From: Ross Bowditch [REDACTED]
Sent: 04 September 2026 08:46
To: Tracie Axford
Cc: Olivier DAVID; Tina Marking
Subject: Re: DM/26/1858 - 7 Portland Road,, EG - Site Visit

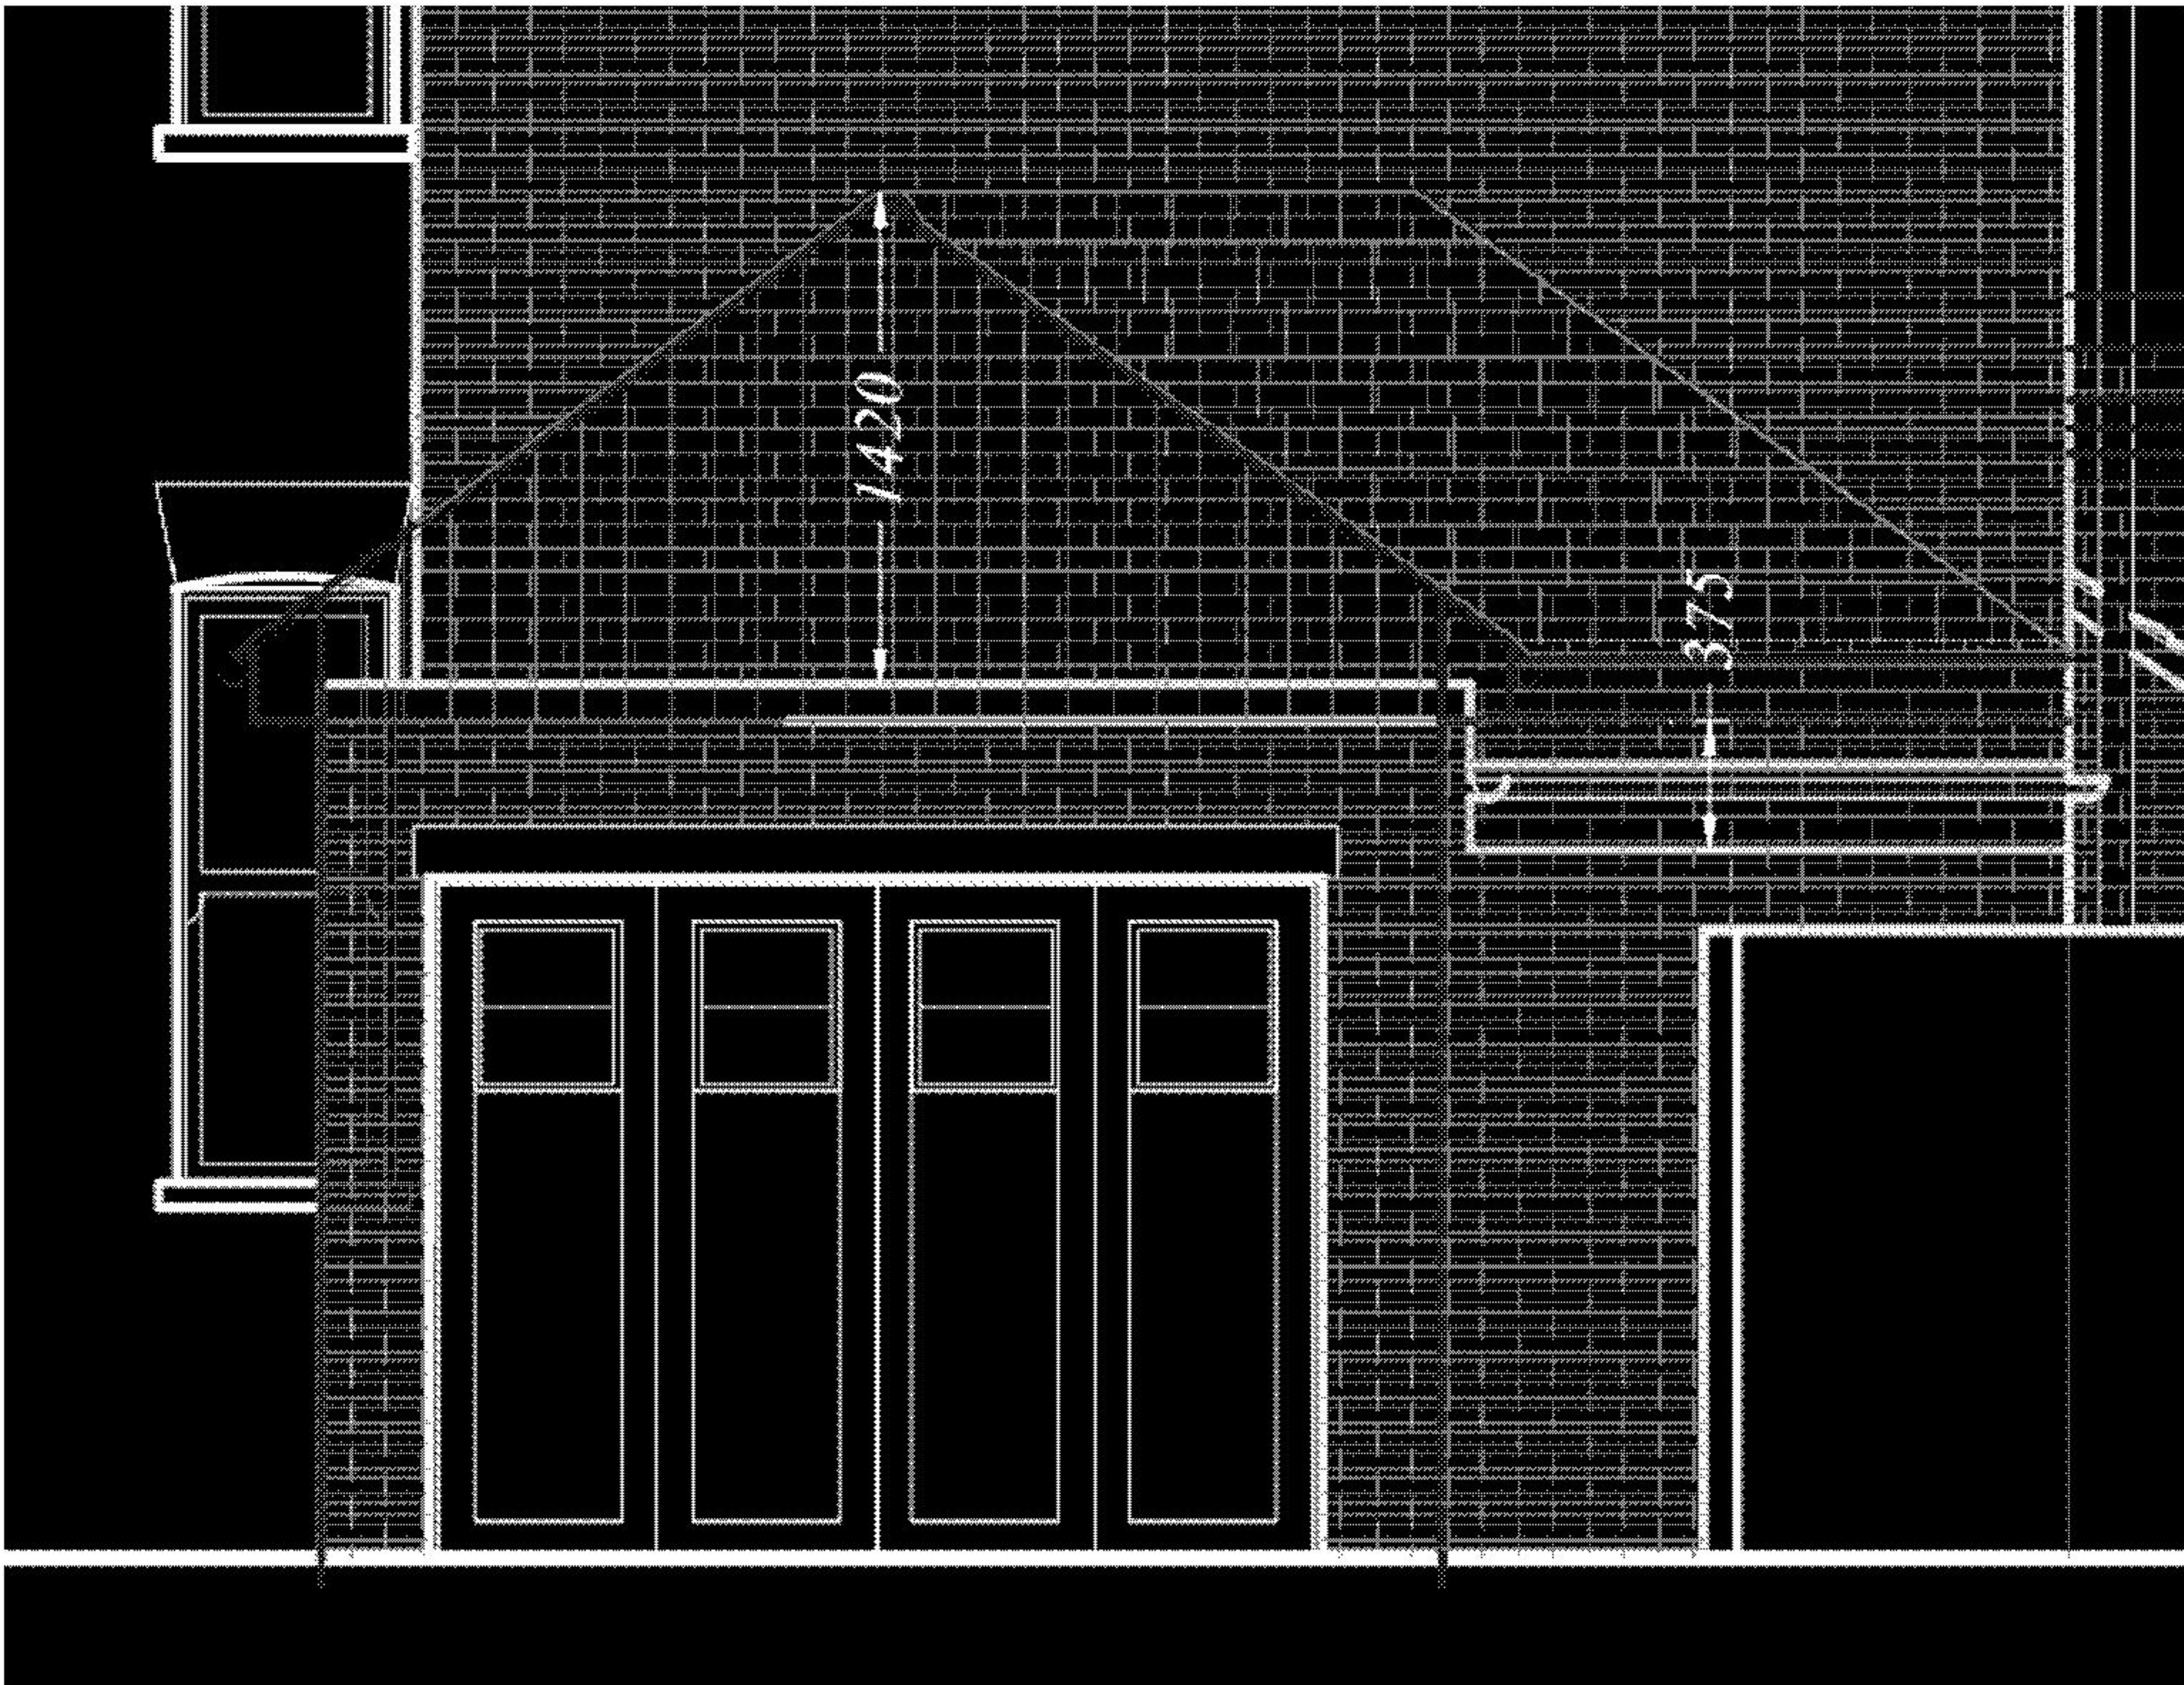
Objection

Overall, the proposed design and renovations to 7 Portland modern standards and the plans are broadly welcome.

Our only objection is that we need to have some further alterations to the garage roof. This potentially impacts on

Please can you include rendering of the proposed garage and 'increase the width of the driveway' to the road access.

The garage roof is to be increased in height as shown below -

So, the eaves will be raised very slightly by 375mm and the overall height in the centre by 1.420m. I wonder, once you have carried out your site visit, whether you can let me know your thoughts ? If you feel that this would be too imposing, I can of course look to reduce this.

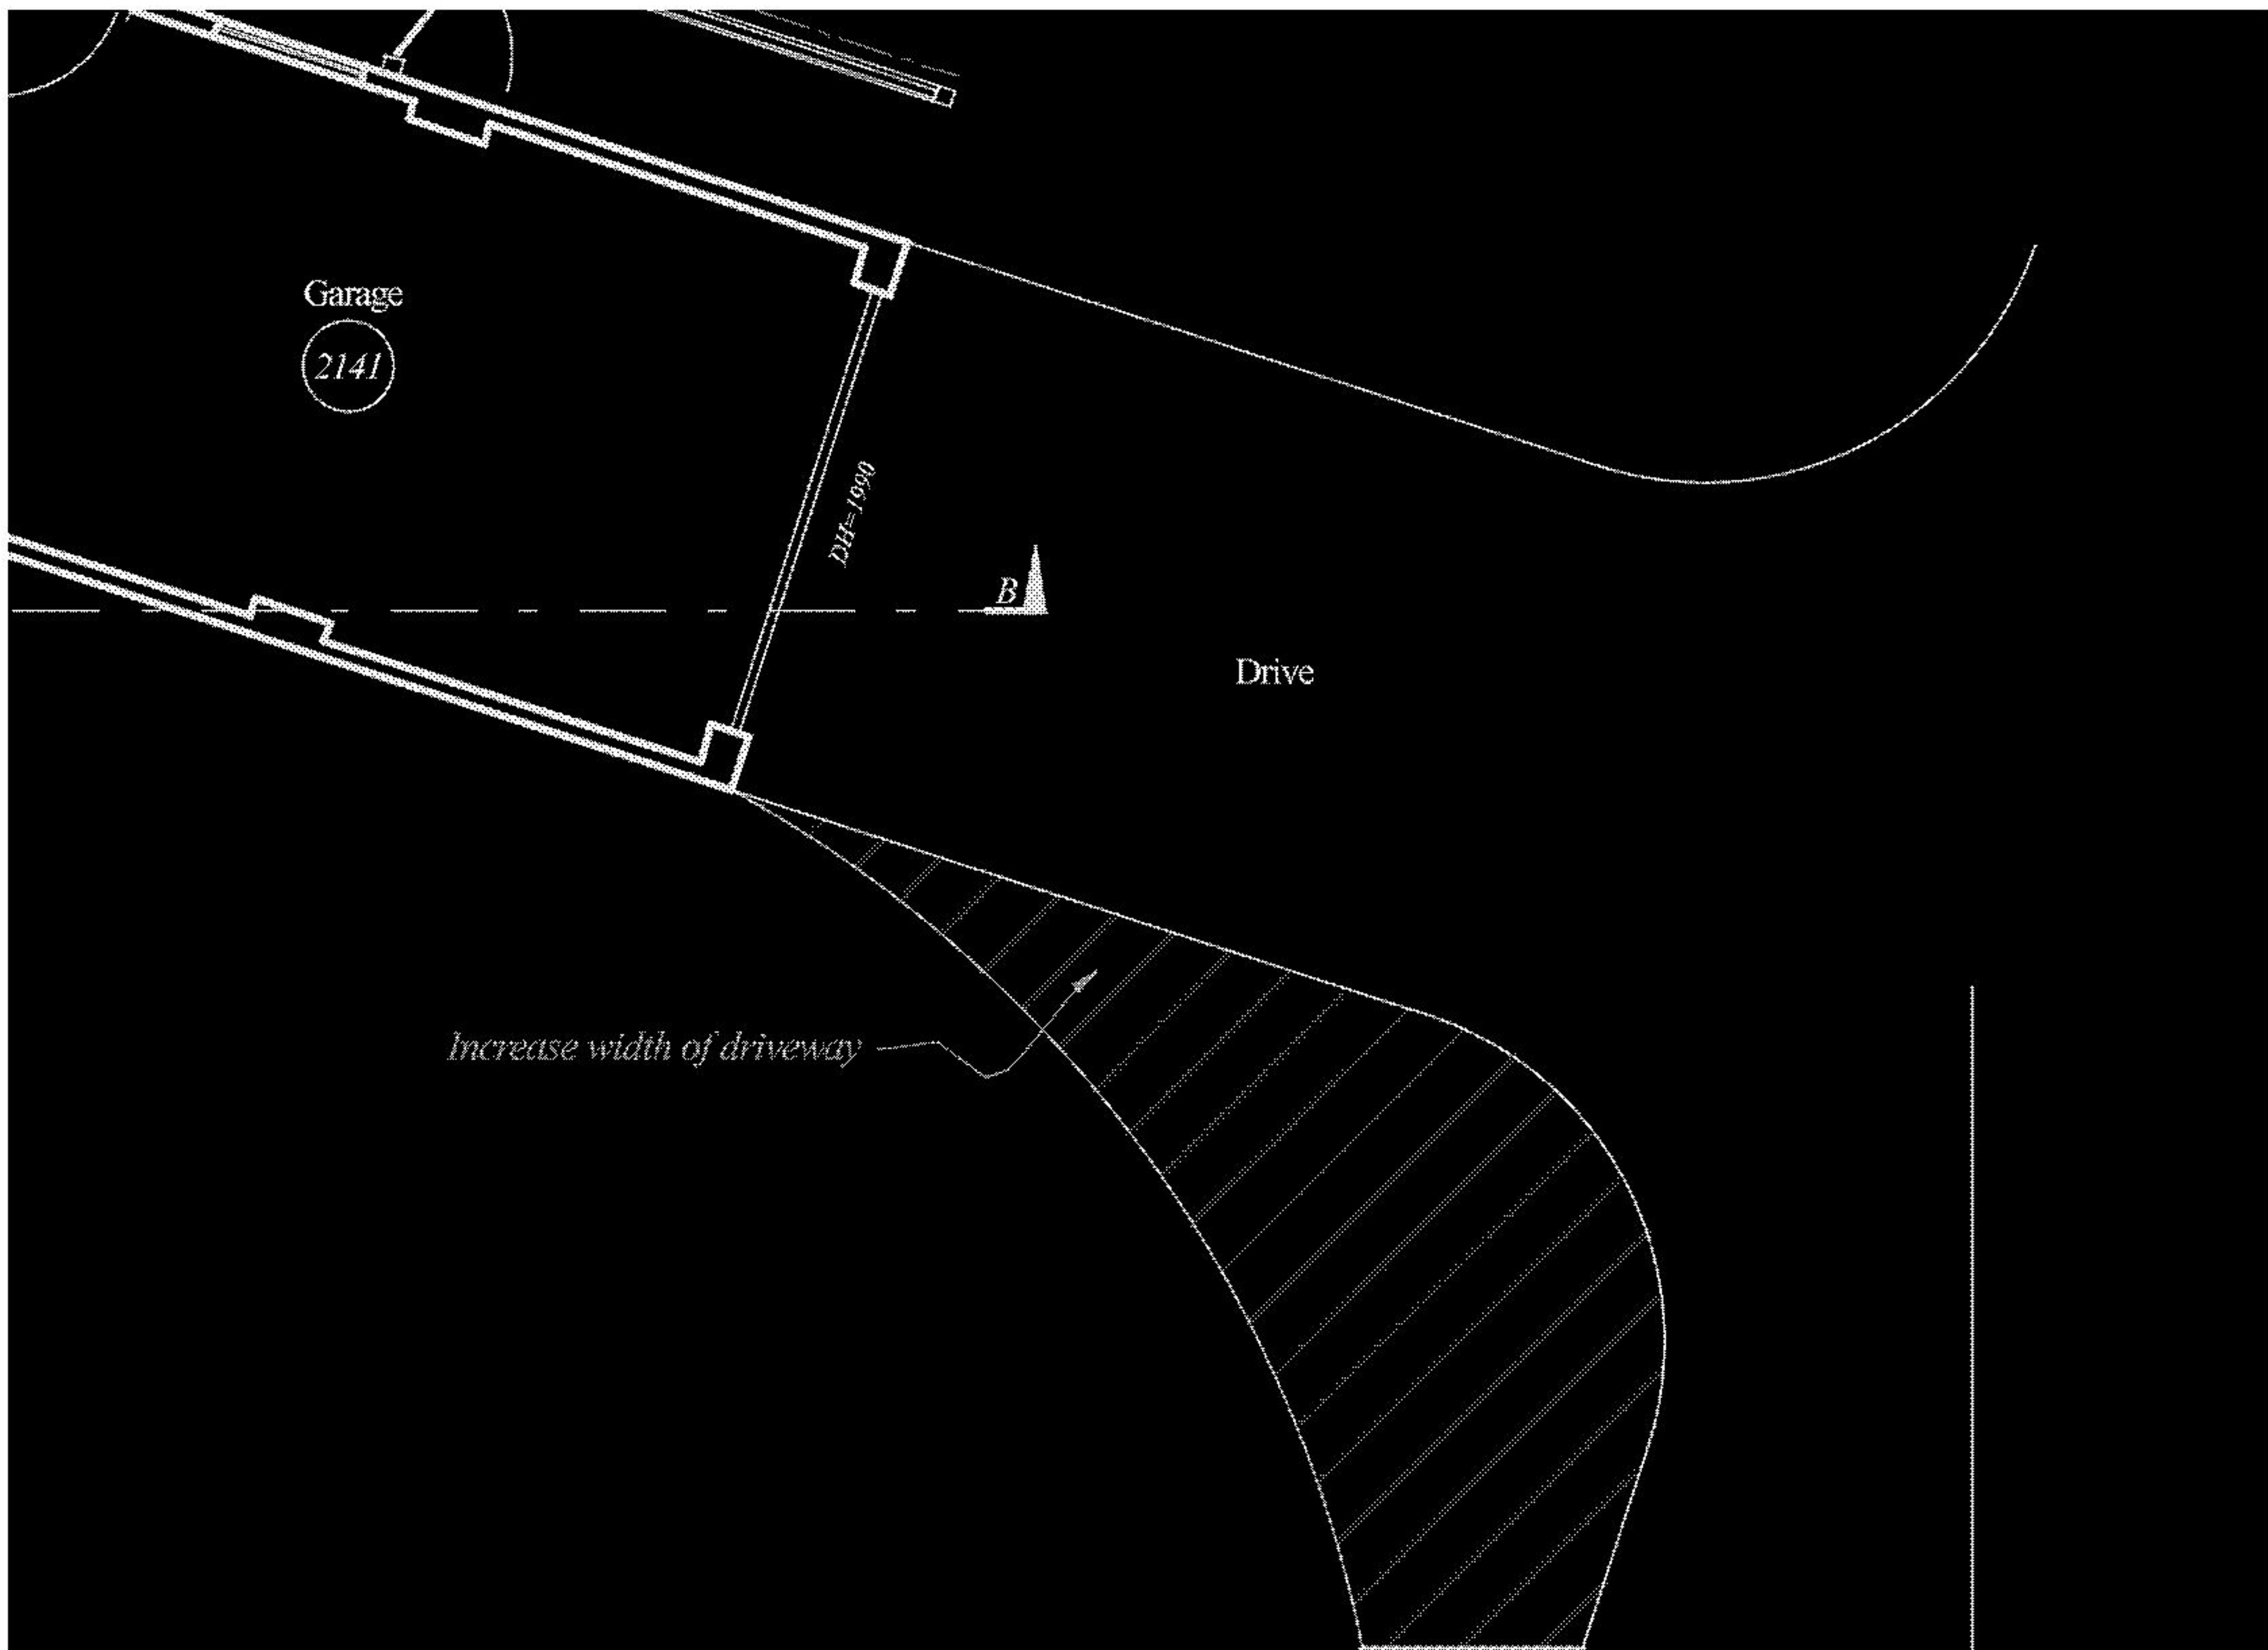
With the driveway, it is the hatched section below that will be added, away from number 9 -
